**ITEM 5. DEVELOPMENT APPLICATION: 40 - 46 MCEVOY STREET WATERLOO****FILE NO: D/2013/1150****DEVELOPMENT APPLICATION NO: D/2013/1150****SUMMARY****Date of Submission:** 9 August 2013, amended drawings 15 November 2013**Applicant:** Karimbla Construction Services (NSW) Pty Ltd.**Architect:** Tony Caro Architecture Pty Ltd.**Developer:** Karimbla Properties (No 30) Pty Ltd.**Owner:** Karimbla Properties (No 30) Pty Ltd.**Cost of Works:** \$60,286,105**Proposal Summary:** Construction of a 6 storey mixed use development comprising of 3 buildings accommodating 232 residential units, a 58 place childcare centre and small retail premises, basement car park for 177 vehicles, site landscaping and public domain improvements.

**Figure 23:** Proposed indicative mid-level floor plan showing building separation.

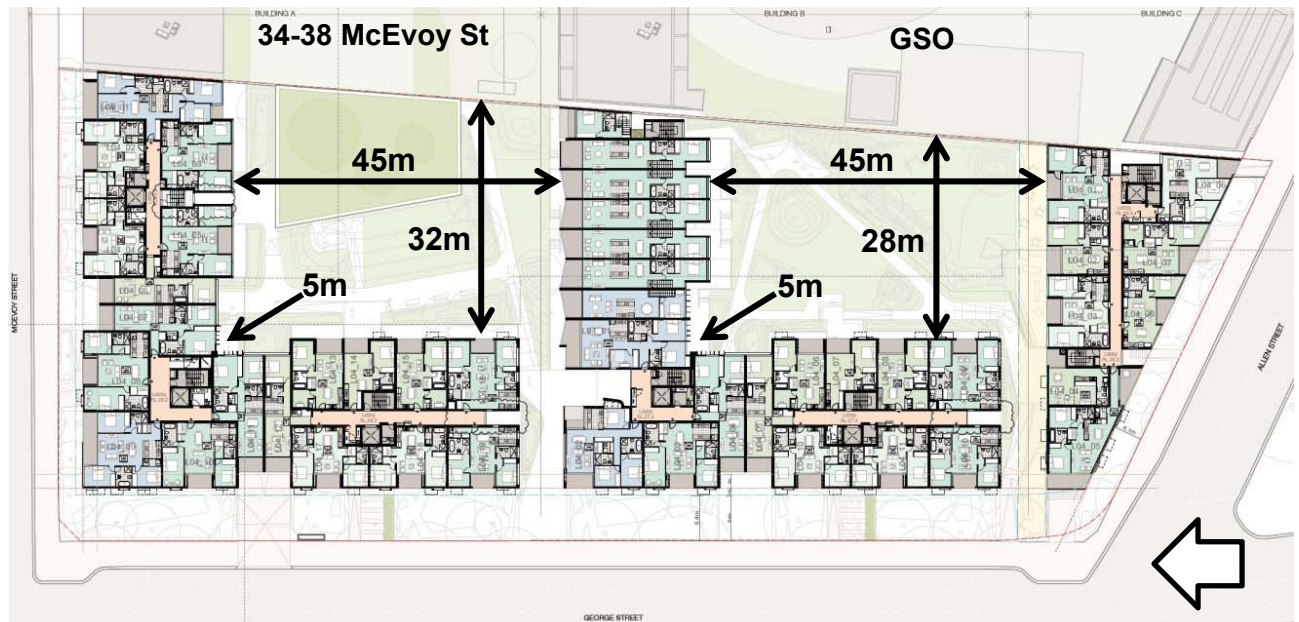
Distances in excess of 45m are afforded to the residential apartments in the GSO development which is considered an optimal relationship with that development. The proposed footprint and siting of the buildings allows a minimum 18m separation to adjoining 34-38 McEvoy Street and does not unreasonably preclude residential development on this site.

**Figure 23** illustrates the proposed internal building separation and distances to the boundaries of adjoining properties.

**Figure 24:** Detailed elevation showing the proposed façade elements, materials and finishes.

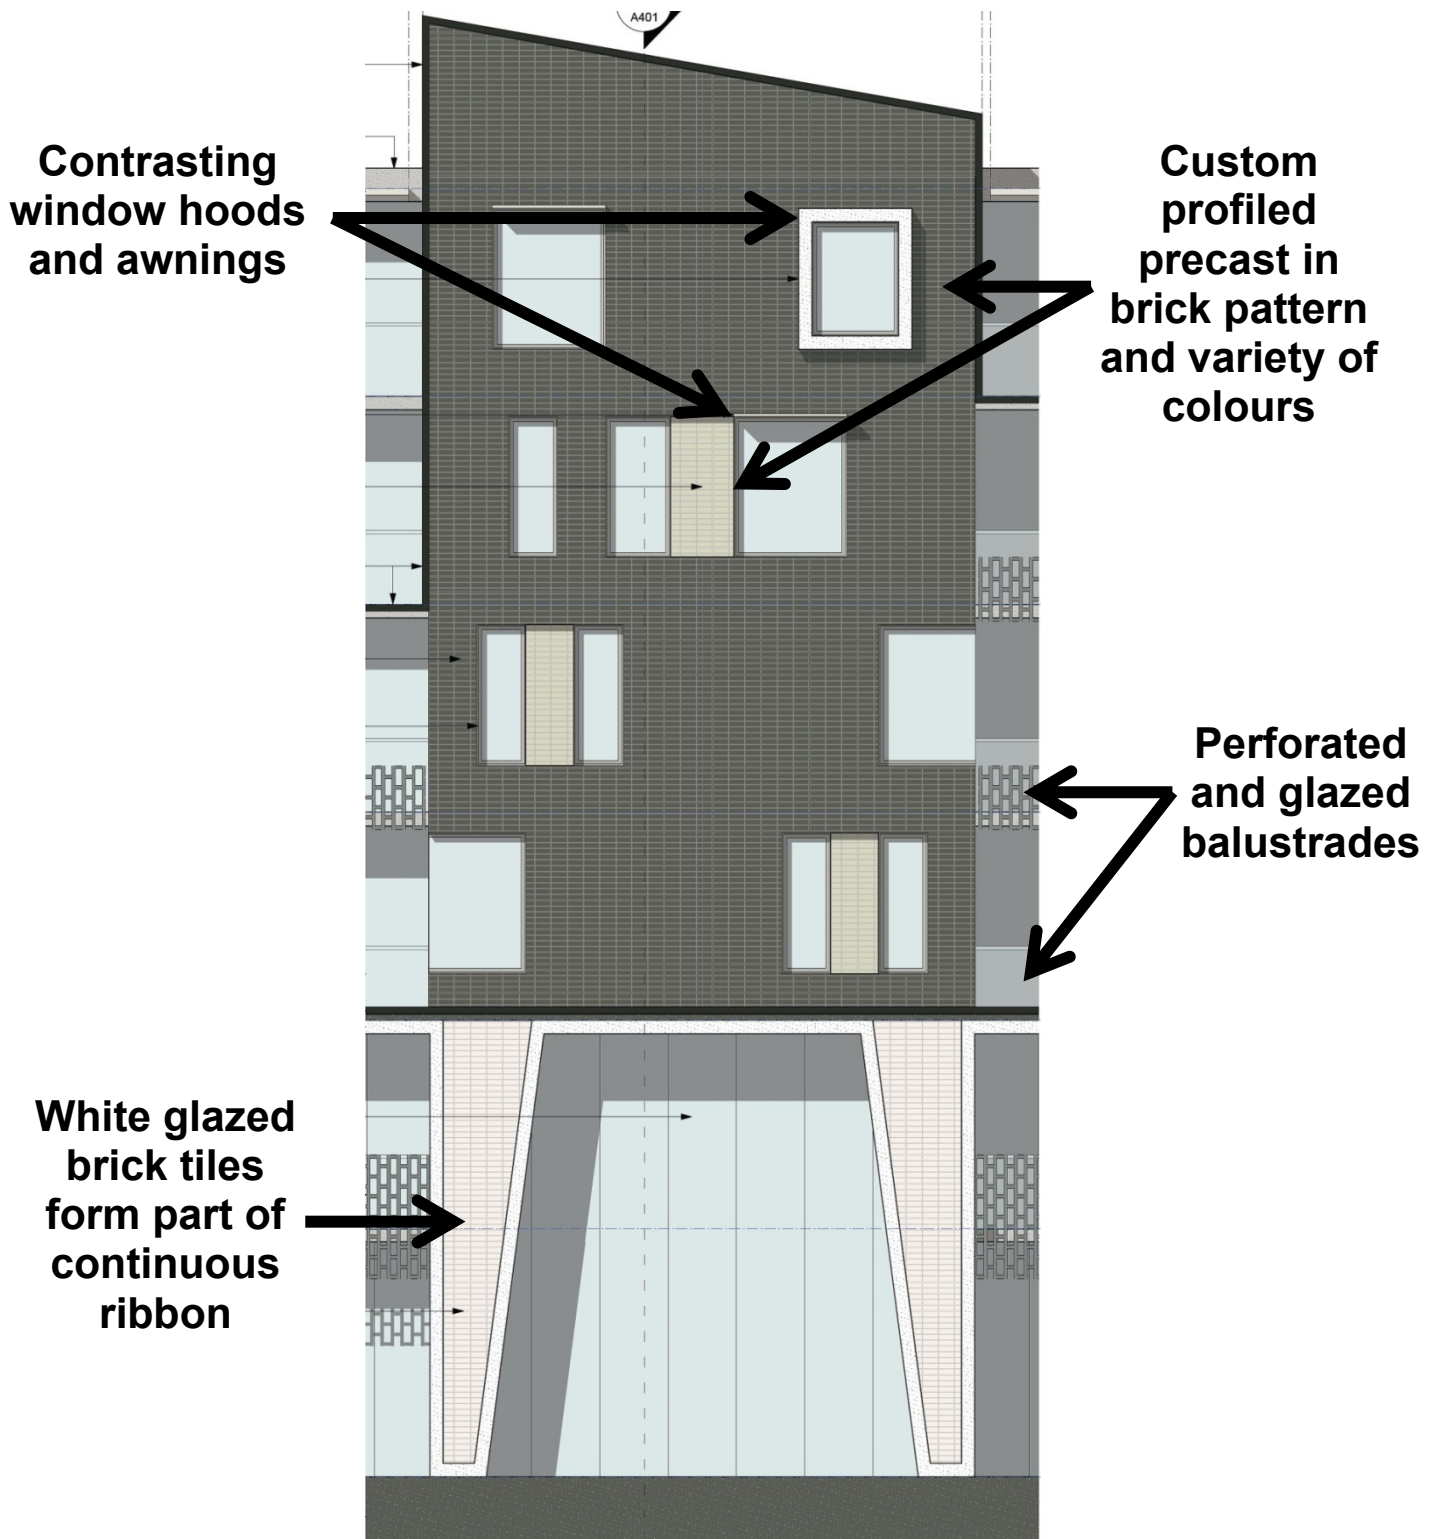
A combination of perforated metal balustrades, part glazed, masonry and cladded are adopted along the street facades.

**Figure 24** illustrates details of the façade and the varied use of materials.

It is considered that the use of precast concrete in various finishes and applied patterns results in an overall aesthetic that appropriately responds to the character of the locality while establishing a strong presence in the streetscape.

**Figure 25:** Landscape concept plan showing proposed Allen Street setback (4.1m) compared setback control (6.4m) and GSO setback.

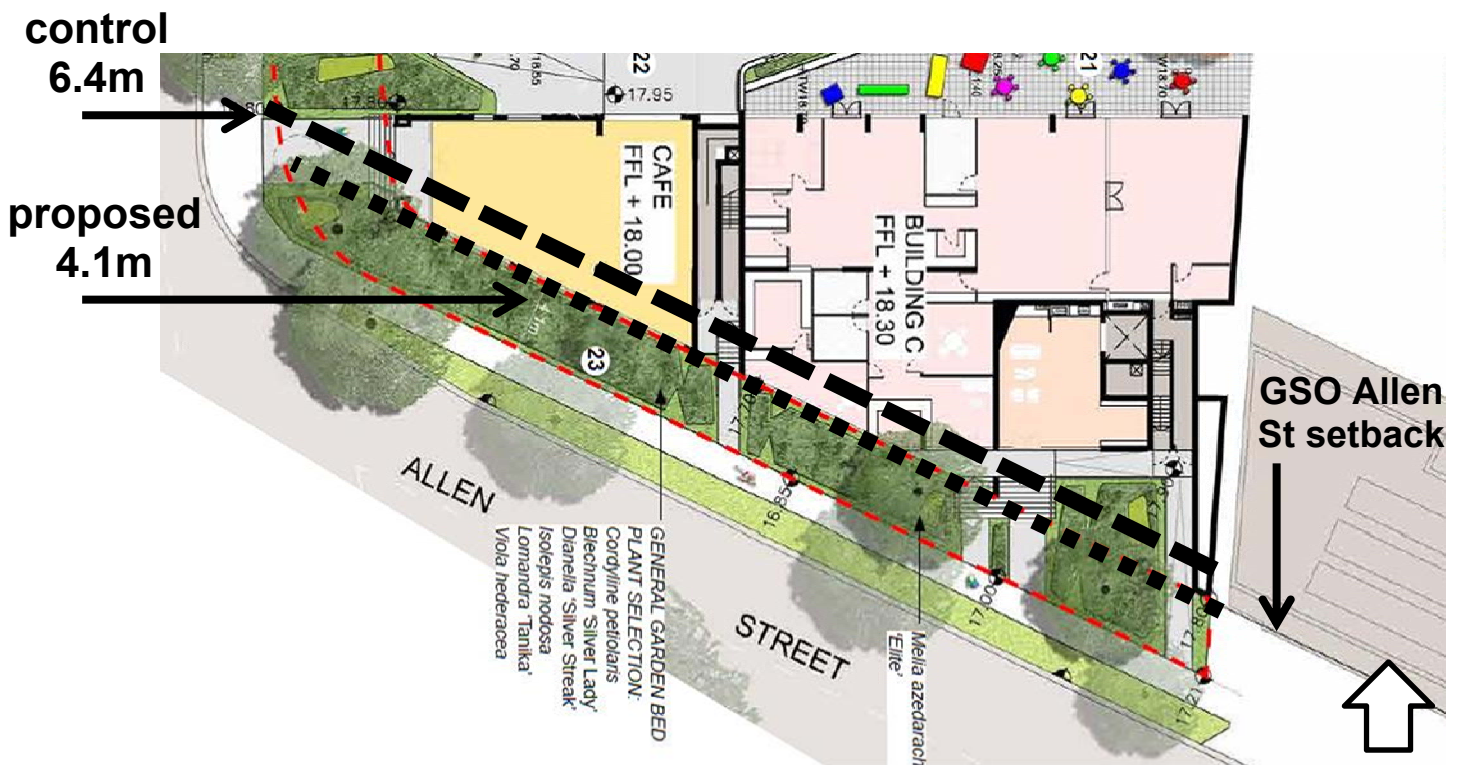
52. SDCP 2012 requires dedicated front setbacks of 6.4m along George Street and Allen Street and 2.4m along McEvoy Street for the purposes of public domain improvement (landscaping). The buildings comply within the control with the exception of the Allen Street setback which provides a setback of 4.1m, where 6.4m is required.
53. **Figure 25** illustrates the proposed 4.1m setback, 6.4m control setback and landscape concept for the Allen Street setback.

54. The objectives of the building setback controls contained in sections 4 and 5 of SDCP 2012 seek to ensure that development is generally consistent with existing, adjacent building setback patterns of the street, introduces landscaped front setbacks to supplement the public open space, enhance pedestrian amenity, privacy and the setting and appearance of buildings.

55. The proposed building setback to Allen Street is consistent with the adjacent building setback pattern established by the GSO building to the east (refer to **Figure 25** above).

Figure 28: Ground floor plan showing direct access to communal courtyards as recommended through design modification conditions.

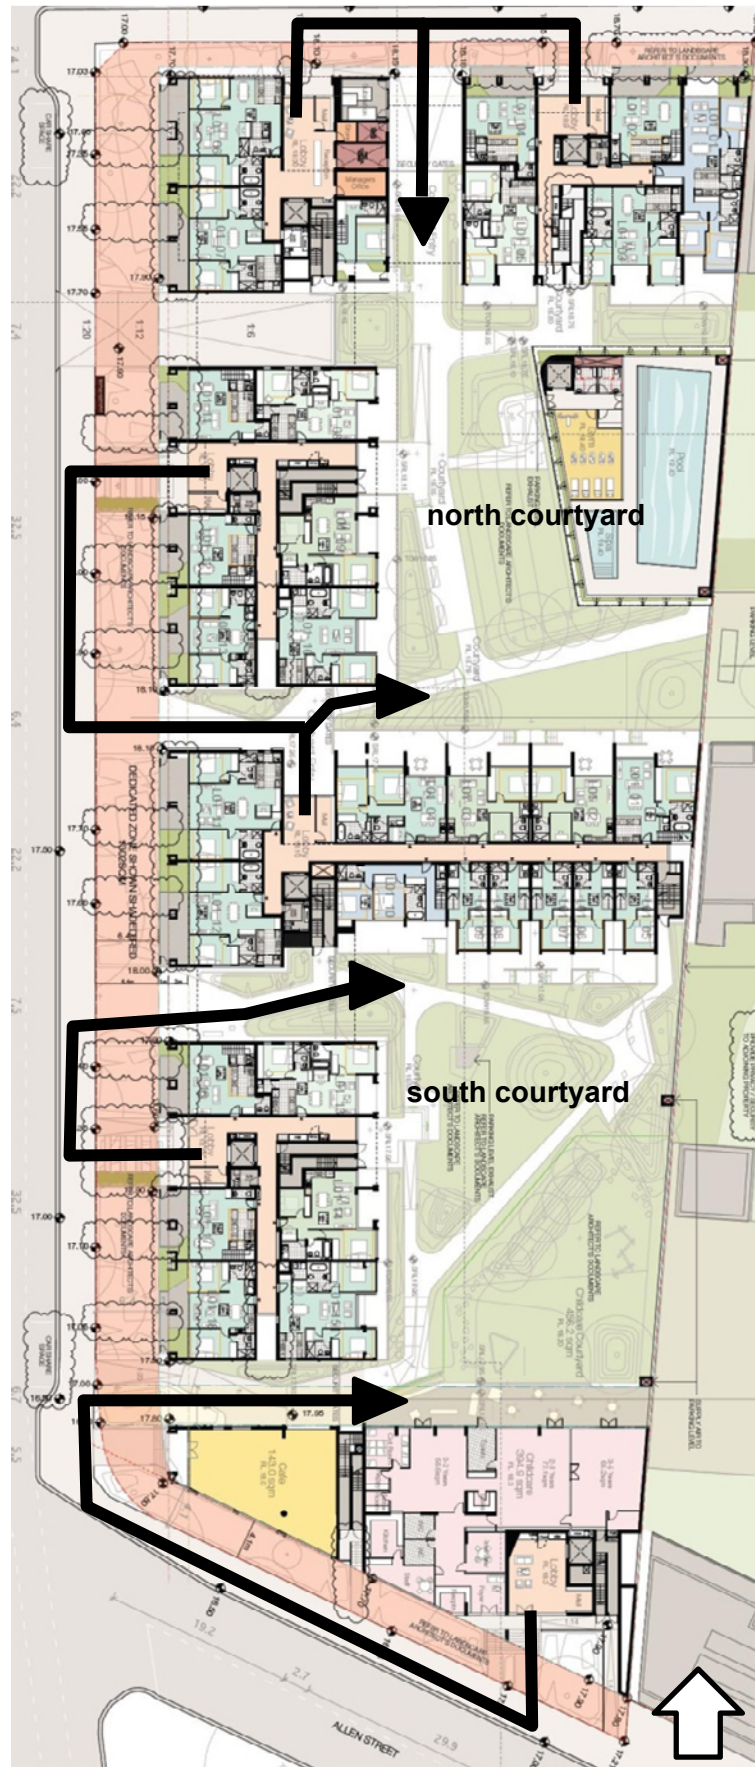
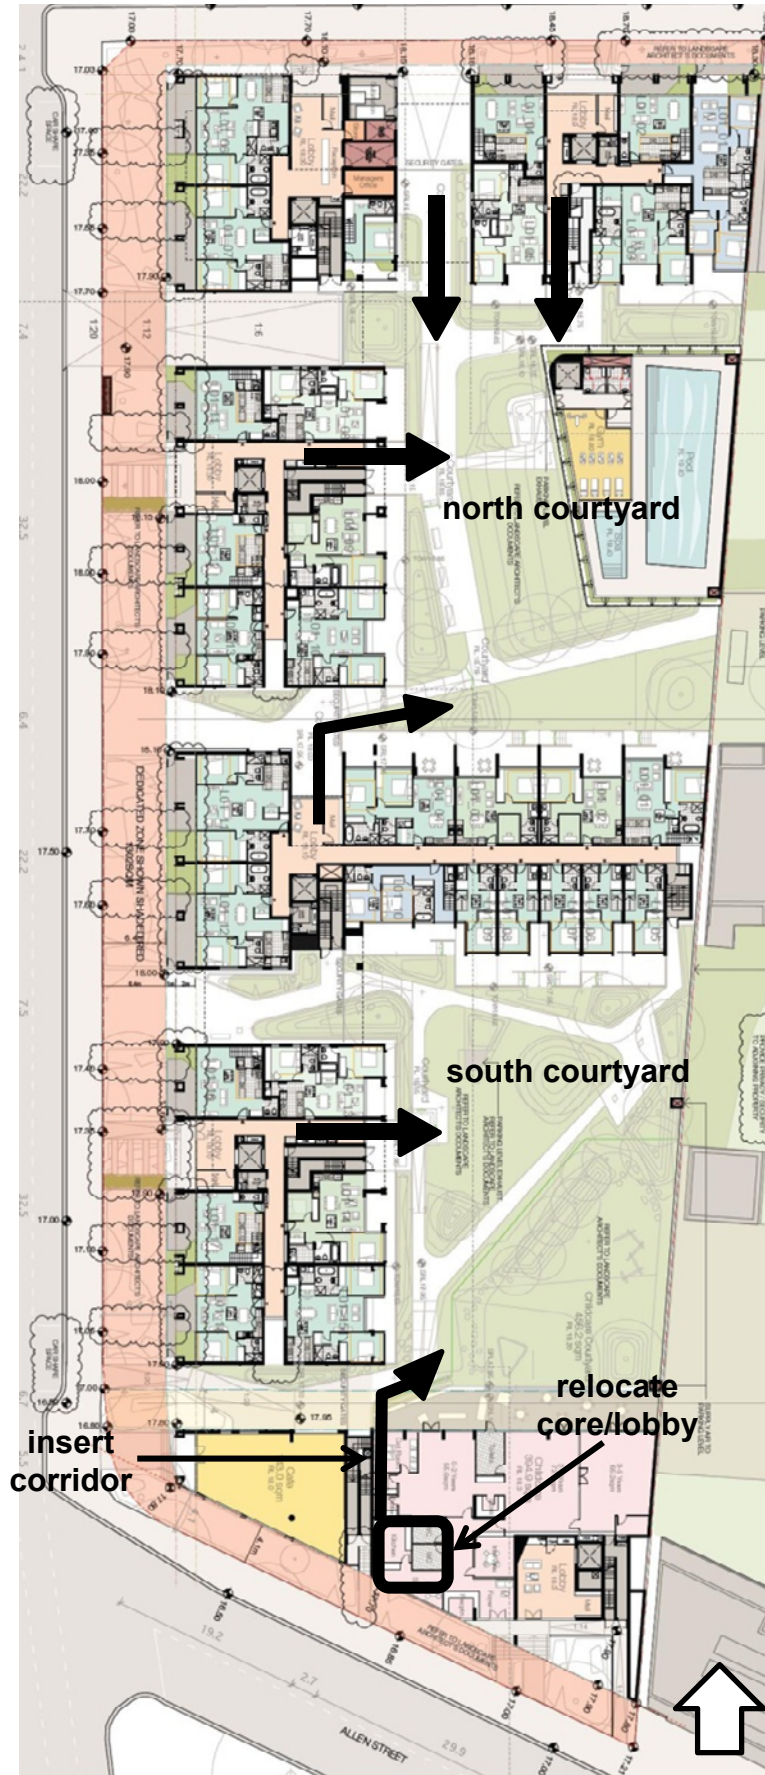
67. The common open space is in the form of two separate landscaped courtyards divided by the east-west wing of Building B (referred to as north courtyard and south courtyard).
68. Direct access from the ground floor lobbies of all buildings to their respective communal open space is not provided. The affect is residents wanting to use the open space are required to take a circuitous route outside of the development and re-access the development from the street.
69. **Figure 27** illustrates the proposed circuitous routes from the residential lobbies to the courtyards.

Figure 27: Ground floor plan showing proposed routes residents would need to take to access their respective communal courtyards.

70. It was requested that the applicant address the issue by providing direct routes that did not require exiting the development and re-entering from the street. The design was amended to provide a lift from the basement level directly into the recreation pavilion, allowing residents to take the lift to the basement, walk through the basement and take the lift up into the recreation pavilion.

- (b) Building B – provide a door from the lobby directly into courtyard (south); and
  - (c) Building C – relocate lift core and lobby south to where kitchen in child care centre is currently located and provide corridor to directly access courtyard (south). This change to the design that effects layout of all levels of Building C, however, these changes are not considered significant that would adversely alter the form and expression of the building.

74. **Figure 28** illustrates the effect of the design modification conditions on the development.
